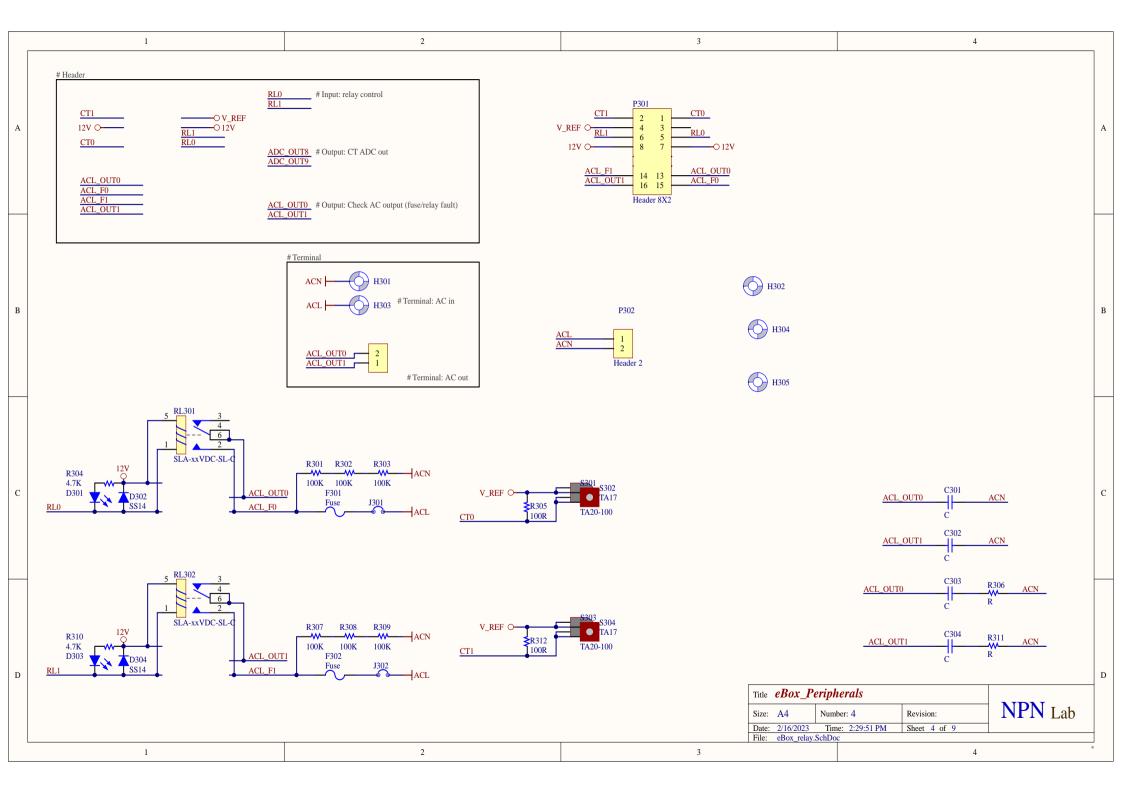
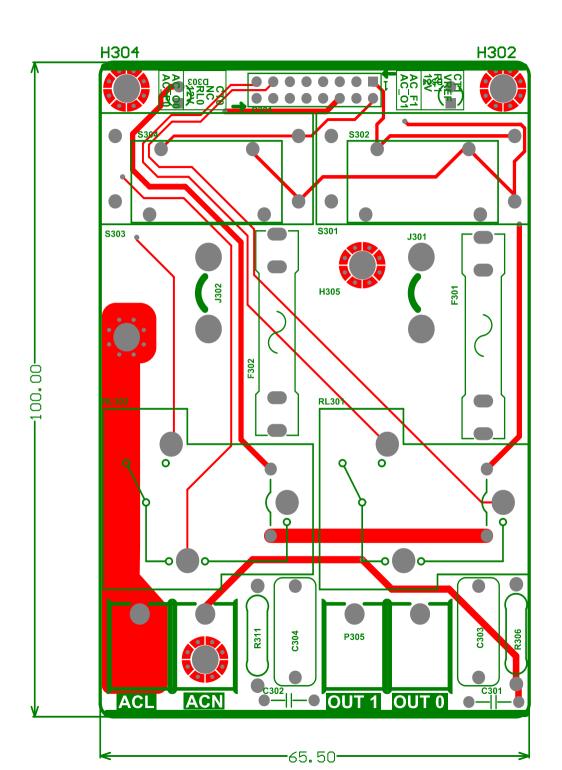
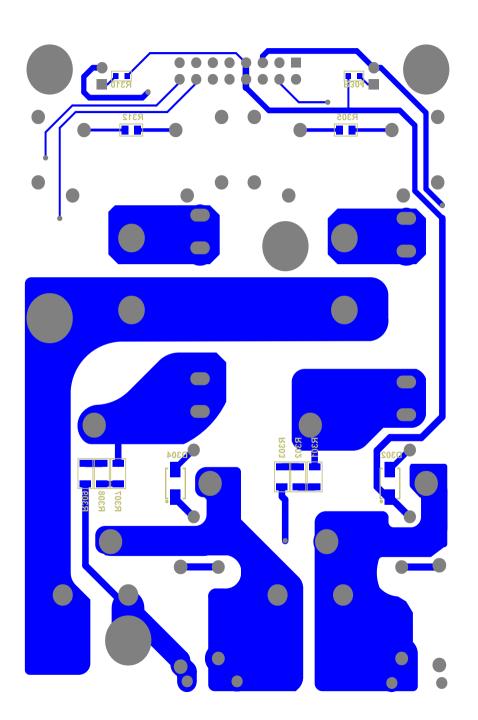
12/12/2019   0.5   (x) Thêm chân nap cho STM32   (x) Chinh số cho nguồn 3G (R1,R2)   hoặc recommend cái nào thi tô địm (x) Thêm tet spoint cho mày chỗ nguồn 12v, 3v3, 1v8   (x) Đền led blink trang thái chân B2   (x) Sim 5320 cũng ra hàng rào hoặc test point tuart để test	12/12/2019   0.5   I <sub>X</sub>   Thêm chân nap cho STM32   I <sub>X</sub>   Chinh số cho nguồn 3G (RLR2)   hoặc recommend cải nào thi tô đậm   I <sub>X</sub>   Thêm the spoint cho mày chổ nguồn 12V, 3V3, 1V8   I <sub>X</sub>   Den led blink trạng thái chân B2   I <sub>X</sub>   Sim 5320 cũng ra hàng rào hoặc test point uart để test   24/12/2019   0.6   - Add PCB layout	07/12/2019	0.3	- C	Change CTs
[x] Them tex point cho máy chô nguồn 12v, 3v3, 1v8 [x] Đền led blink trang thái chân B2 [x] Sim 5320 cũng ra hàng rào hoặc test point uart để test  24/12/2019 0.6 - Add PCB layout  29/12/2019 0.7 - Fix bug  27/02/2020 1.0 -  25/05/2020 2.0 - Pre-mass production (20 pcs)  12/03/2021 2.1 - Keep CTs 1 to 8 is 5A the same, the others change to 10A - Add wifi modules ESP-01 and ESP-05. Just use only one, the other for backup Bigger screw hole for more easy assembly - Fix the transformer footprint  31/01/2023 3.0 - New version with Thaco - Stackable, easy install and remove - Relay board add sumbber - Relay board add sumbber - Relay board add sumbber - Relay board resize and change connect to flat - Led board change to led & connector smd - Main board add New wifi/lan module	Same of the state of the stat	09/12/2019	0.4	- A	Add PCB document

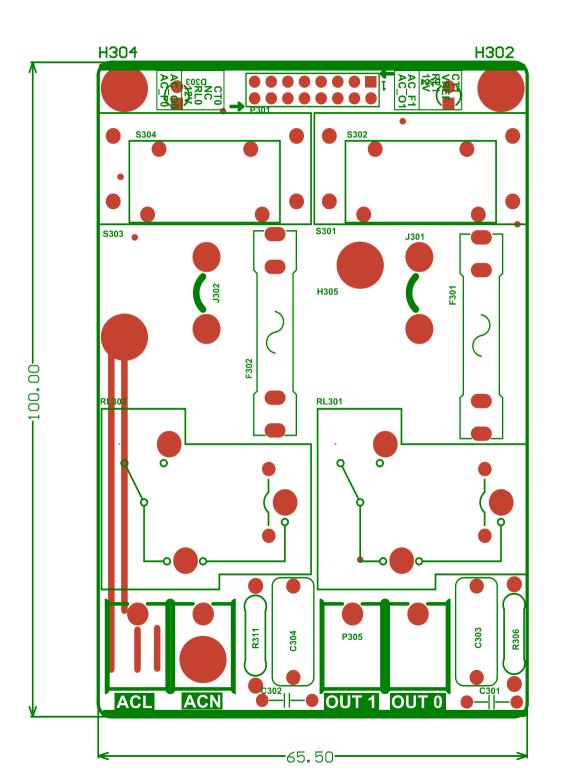
- -ACN Terminal to corner bottom right +check sze of snubber component -Region for fuse , thermal absorb
- Open air for acl
- tear drop
- label
- should removr 3 resistor serial & CT small?
- Rechack relay pin on ACL line , change footprint
- co ve chan acl cua header 8x2 chua dung
